PCN - Process Change Notification

Change:	CAB.720
Date:	2016/06/22
Author	Kim Ho

Model#	Part Number	Changes
CAB.720 Cable	CAB.720	Packaging rules changing.
Assembly 200mm 1.32		Add material P/N on BOM.
Hirose U.FL to		Amend tolerances.
SMA(F)BKST

Old drawing

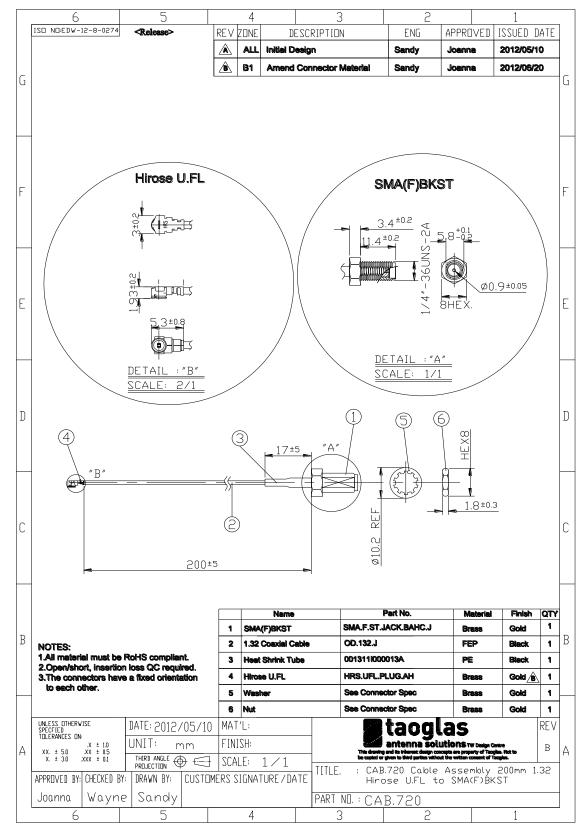
- 1.Due to Taoglas will input Barcode tracking process, we need to amend the packaging rules and labelling on barcode labels on standard packaging quantity bag and cartons.
- 2. Add material P/N on BOM
- 3. Amend tolerances.
